PUBLIC INVOLVEMENT SUMMARY

**I-35 and SH-9W Interchange
McClain County, Oklahoma
JP 19314(04)**

**Oklahoma Department of Transportation
200 N.E. 21st Street
Oklahoma City, OK 73105**

January 2022

JP 19314(04)
SH-9/I-35, McCLAIN COUNTY
OPTION 2B - (DDI) DIVERGING
DIAMOND INTERCHANGE + RELIEVER

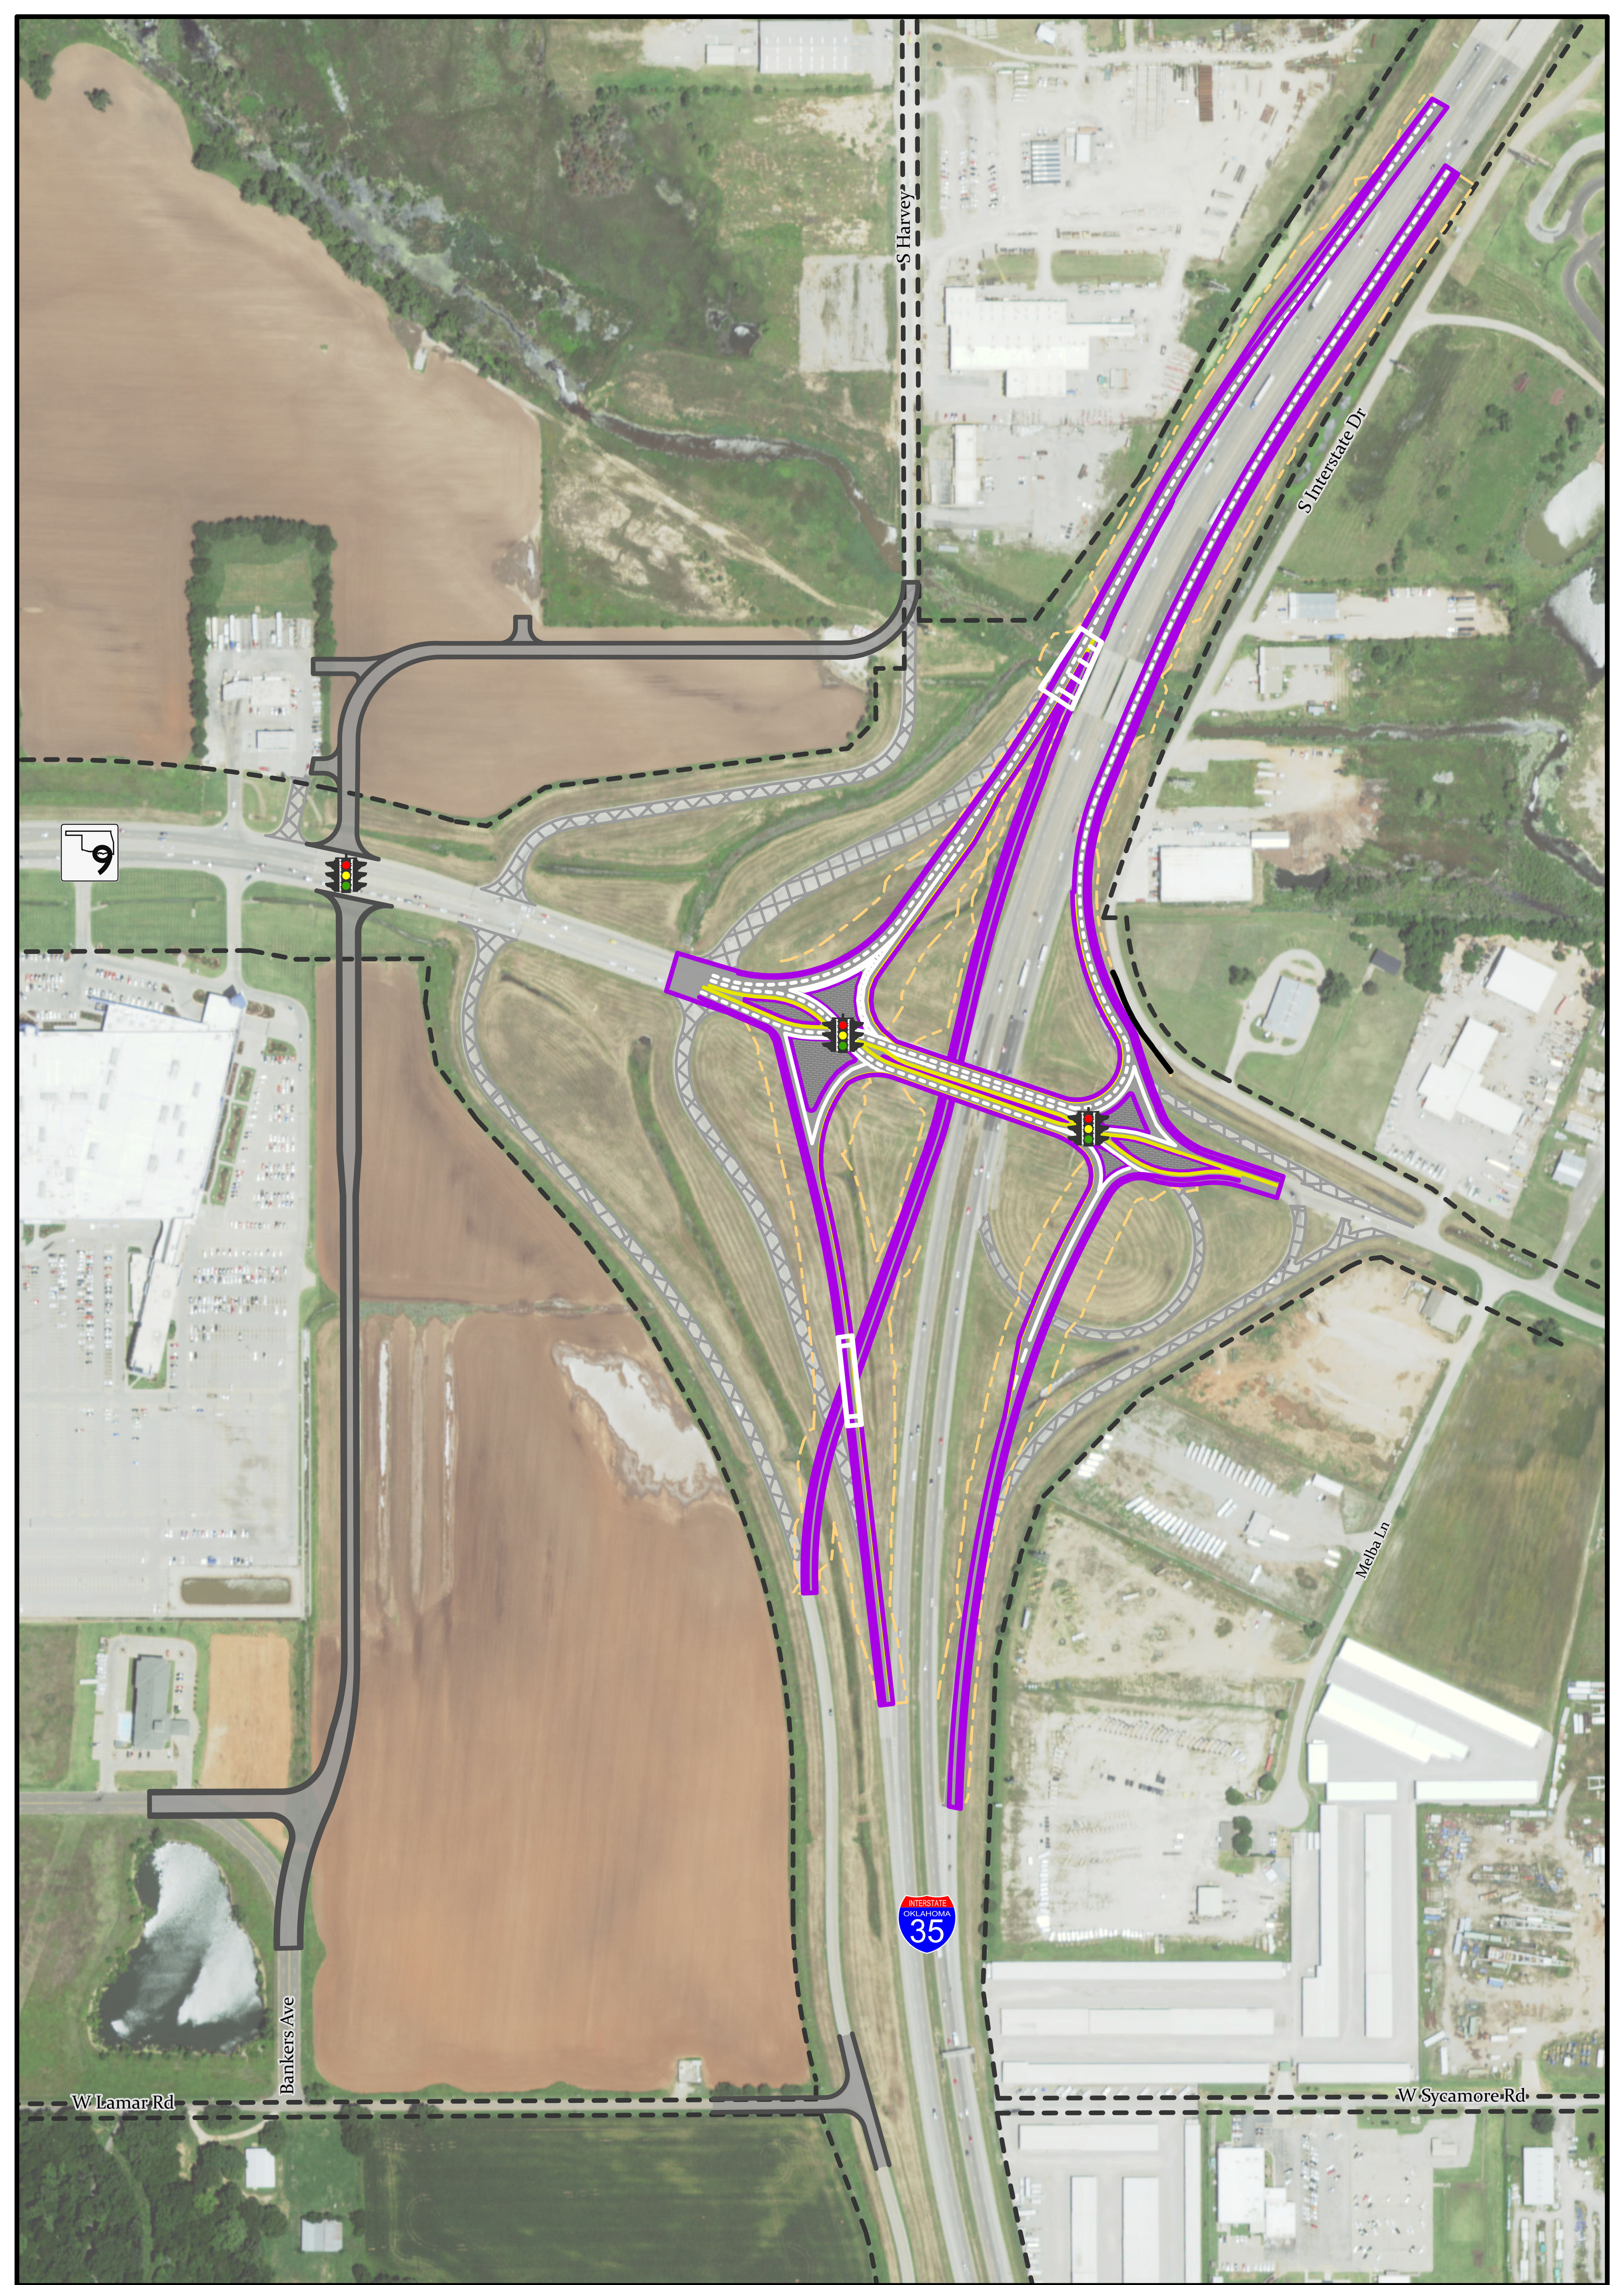
Two (2) comments were received from municipalities: the Town of Goldsby and the City of Newcastle. Both municipalities were in support of the interchange project and preferred Alternative 2B – the Diverging Diamond Interchange with the Reliever Ramp. Both municipalities also believed that the project area was rapidly growing and construction projects for homes were being planned. ODOT thanks the municipalities for their comments, insights, and stated preferences.

Five (5) comments were received requesting two dedicated exit lanes to westbound SH-9W. In response, all of the Alternatives include at least two southbound I-35 exit lanes and will address the traffic congestion by improving the traffic operations.

Three (3) comments were received requesting two dedicated entrance lanes to northbound I-35. ODOT notes that all of the Alternatives include at least two northbound I-35 entrance lanes and will address the traffic congestion by improving the traffic operations.

ODOT reviewed the operations, comments from the public, and the overall interchange analysis and has decided to move forward with Alternative 2B – the Diverging Diamond Interchange with the Reliever Ramp. From the alternatives matrix, Alternative 2B has the best combination of operational improvements, cost effectiveness, and reduced future maintenance concerns. Alternative 2B has strong support from the public and from two major stakeholders, i.e., the Town of Goldsby and the City of Newcastle.

ODOT's decision was based upon many factors. Alternative 2B was ranked the highest in operational efficiency in both the current year and the projected 2050 timeframe. This is demonstrated by Alternative 2B ranking the lowest in average delay, the lowest in average travel time, and the highest in average vehicle throughput. In addition, Alternative 2B's design alleviates many common interchange issues, which include snow and ice treatment on loop ramps, potential wrong way movements on ramps, and greatly reduced conflict points for major movements. The added reliever ramp will also serve new development in the Town of Goldsby and other surrounding areas while helping to reduce congestion on I-35 and SH-9W. Lastly, the project's cost was near the median, but within the current estimate of the ODOT 2022-2029 8 Year Construction Work Plan.
